**Addendum No. 1  
Plans, Specifications and Contract Documents  
for  
The Seed Academy – Lake Cumberland  
Regional AgriTech Center  
Russell Springs, Kentucky**

**ADDENDUM NO. 1 - ISSUE DATE: 6-15-23**

**The Seed Academy**  
Lake Cumberland Regional AgriTech Center  
Russell Springs, Kentucky

AD1.1

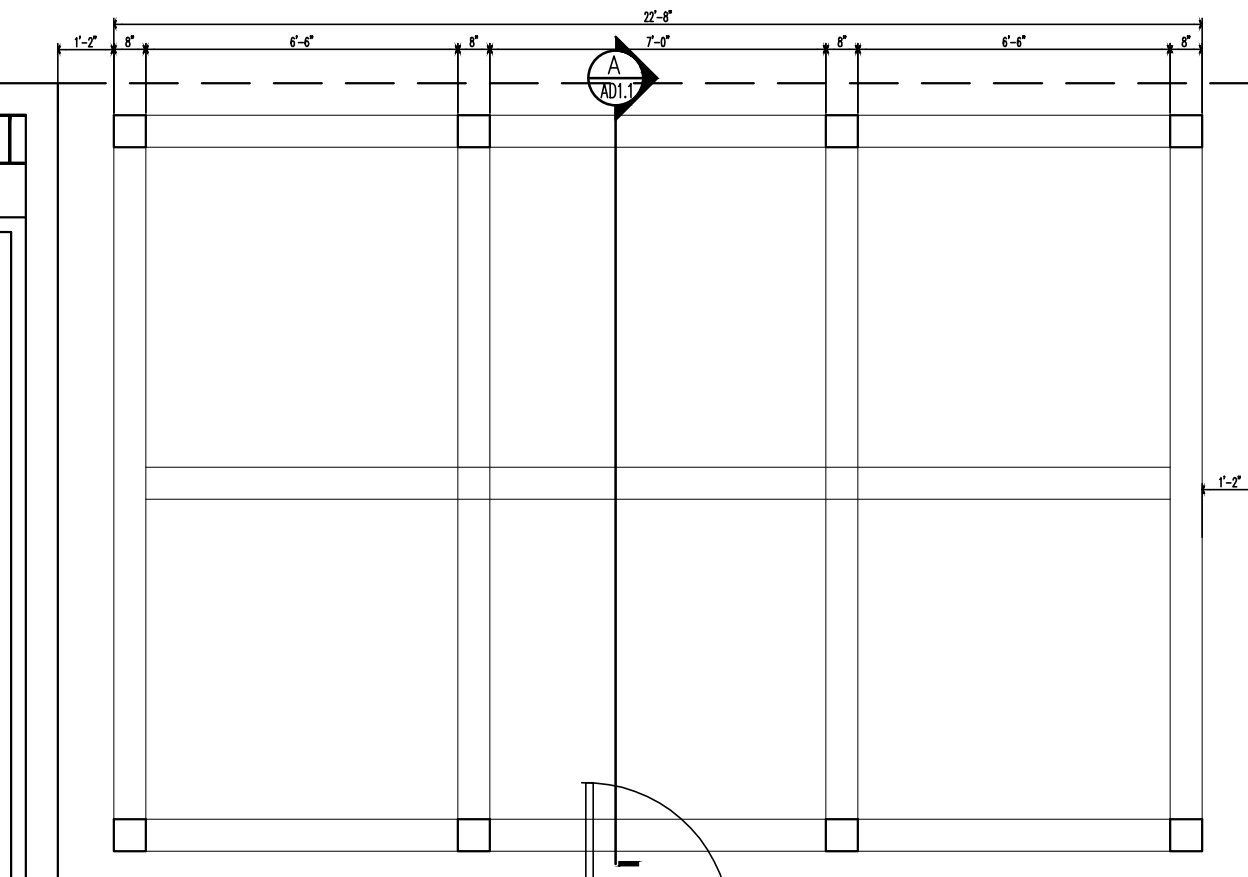
Item 14 – Attached 8.5x11 sheets AD1.1 and AD1.2 shall be added to sheet A-6.

UM-1A

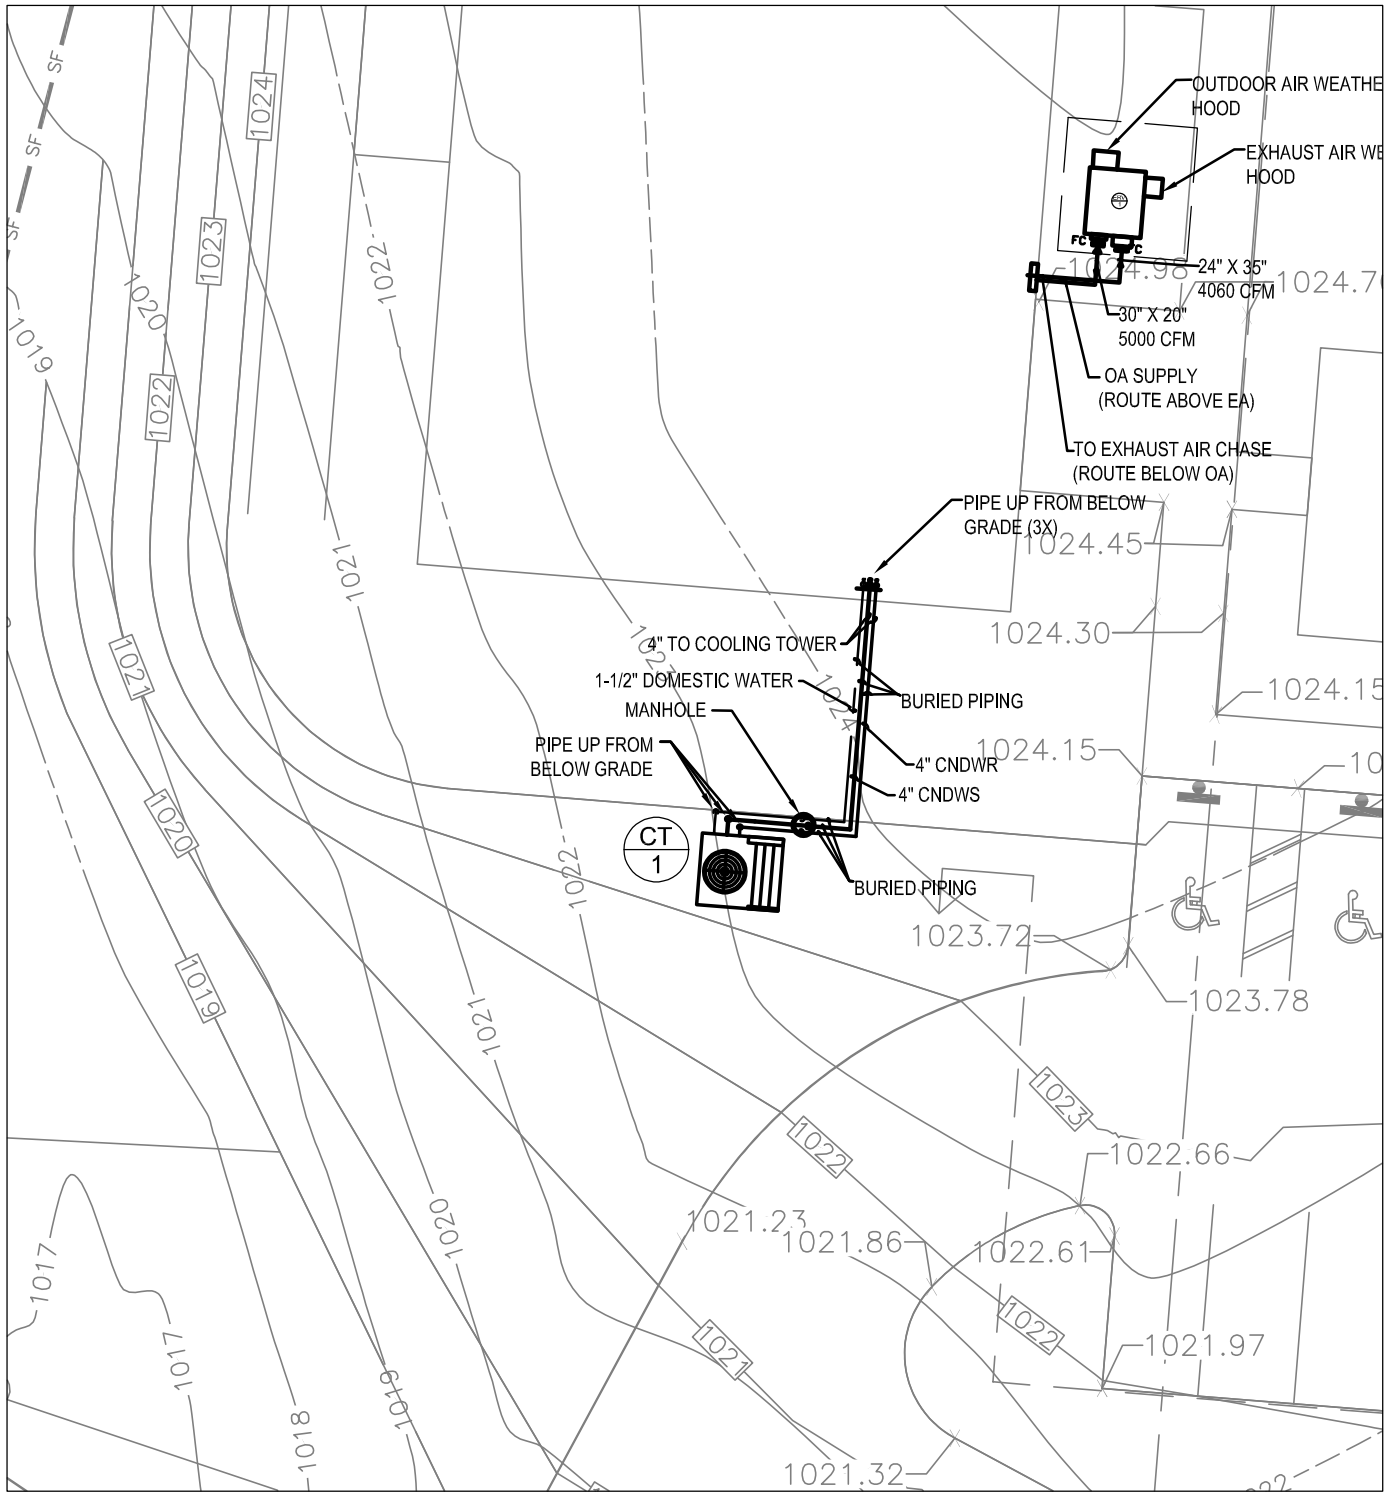
- UM1.1 Refer to Sheet - UM -1:See partial plan UM-1A for changes to contour lines (numbers boxed) around Cooling Tower (CT-1). Note: Location of cooling tower does not change under Alternate #1.
